CERTIFICATE OF APPROPRIATENESS

Property: 1810 Kane Street, Lot 6, Block 443, Baker W R SSBB Subdivision. The property includes a 2,050 SF, one-story, wood frame, single-family residence situated on a 5,000 square foot (50' x 100') interior lot.

Proposal: Alteration

Recommendation: Denial of COA and issuance of a COR to replace the windows per specifications and retain original trim with details.

Figure 9 - Applicant Supplied Photo

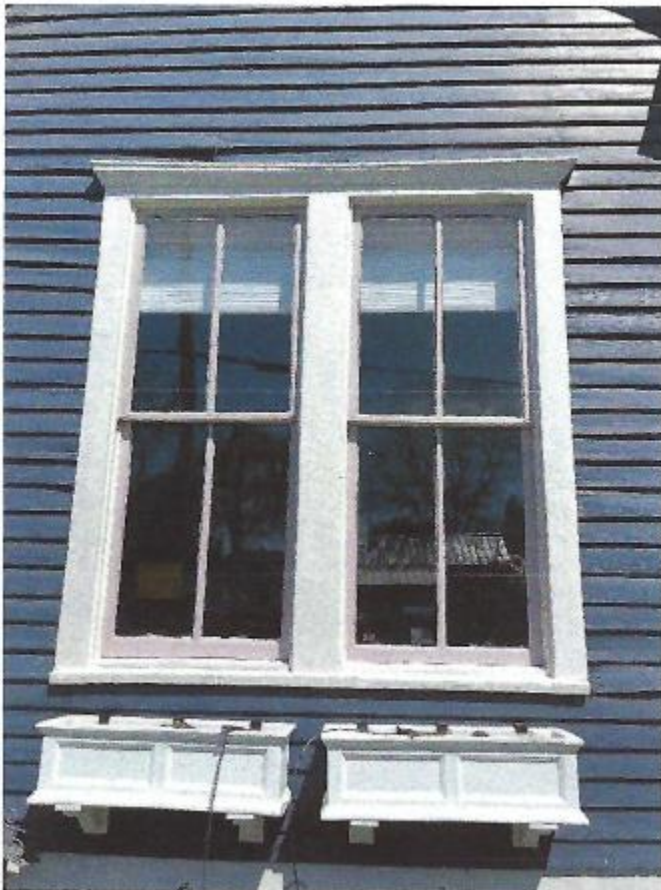
Attached for review are pictures of the front of 1810 Kane showing two of the existing windows as well as the two new windows that were installed on the front porch. As you can see from the pictures, there is no apparent difference between the old and new windows. The new windows are as architecturally correct as possible, and as you can see are both recessed and inset as the existing windows.

Figure 13 - Diagram of Windows to be Replaced

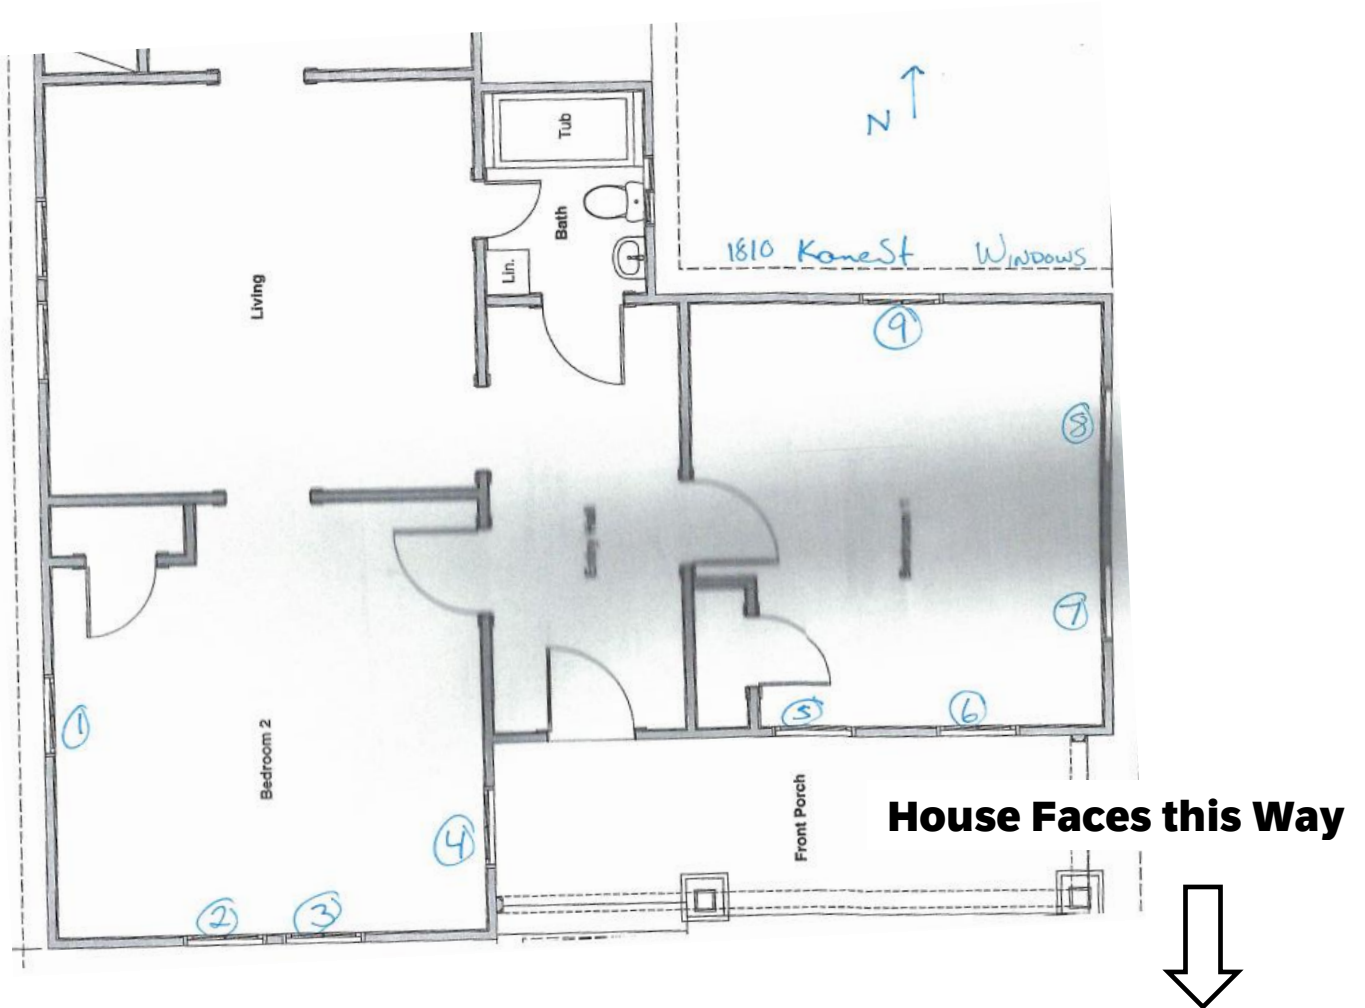
Approximately 7 months ago we ordered and paid for nine, custom, 2 over 2 architecturally correct, Jeld Wen wood frame windows to replace the existing windows. The cost for the 9 windows is approximately \$15,000 (nonrefundable) and installation will cost another \$12,000 or so. The intent is to reuse as much of the existing trim as reasonably possible. One window is on the west side of the house, five windows are along the front (south side) of the house, one window is on the east side of the house and one window is on north side opening on the back courtyard. Drawing and window plan is attached.
